PROPOSAL FOR DRAFT AMENDMENTS TO REGULATION No. 11

Note: The text reproduced below was prepared by the expert from the European Commission in order to extend the scope to vehicles in categories N<sub>2</sub> and N<sub>3</sub> and add requirements on steps and running boards.

Figure 7-1

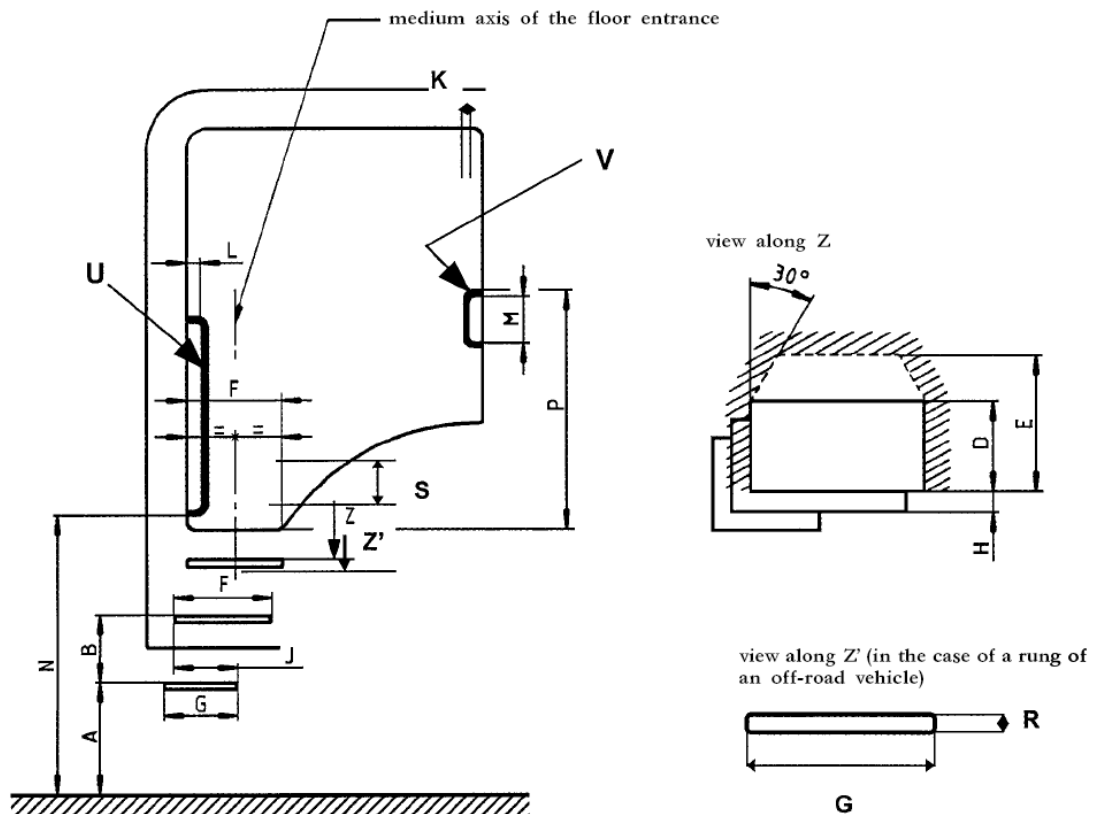
- 1. Access steps to the driver's compartment (see figure 7-1)**
  - 1.1. The distance (A) from the ground to the upper surface of the lowest step, measured with the vehicle in running order on a horizontal and flat surface, shall not be more than 600 mm.**
    - 1.1.1. However, for off-road vehicles, in conformity with the definitions given in the Consolidated Resolution on the Construction of Vehicles (R.E.3) (TRANS/WP.29/78/Rev.1/Amend.2, Annex 7/Rev.2), that distance (A) may be increased up to 700 mm.**
  - 1.2. The distance (B) between the upper surfaces of the steps shall be not more than 400 mm. The vertical distance between two subsequent steps shall not vary by more than 50 mm. The last requirement shall not apply to the distance between the uppermost step and the cab floor.**

- 1.3. In addition, the following minimum geometrical specifications shall be fulfilled:
  - (a) step depth (D): 80 mm
  - (b) step clearance (E) (include step depth): 150 mm

- (c) step width (F): 300 mm
  - (d) width of the lowest step (G): 200 mm
  - (e) step height (S): 120 mm
  - (f) transversal offset between steps (H): 0 mm

- (g) longitudinal overlap (J) between two subsequent steps in the same flight, or between the uppermost step and the cab floor: 200 mm.
- 1.3.1. However, for off-road vehicles (see 1.1.1.) the value (F) may be reduced to 200 mm.

2. Access to handholds to the driver's compartment (see figure 7-1)
  - 2.1. One or more suitable handrails and handholds or other equivalent holding devices shall be provided for the access to the driver's compartment.

- 2.1.5. The steering wheel may be considered as a handhold.
- 2.2. The height (N) of the lower edge of at least one handrail or handhold or equivalent holding device, measured from the ground with the vehicle in running order on a horizontal and flat surface, shall not be more than 1 850 mm.

- 2.2.3. In addition, the minimum distance (P) of the upper edge of the handrail(s) or handholds or equivalent holding devices from the floor of the driver's compartment shall be:

- (a) handrail(s) or handholds or equivalent holding devices (U) 650 mm,
  - (b) handrail(s) or handholds or equivalent holding devices (V) 550 mm.
- 2.3. The following geometrical specifications shall be fulfilled:

- (a) gripping dimension (K): 16 mm minimum 38 mm maximum,
  - (b) length (M): 150 mm minimum,
  - (c) clearance to vehicle components (L): 40 mm minimum with open door.
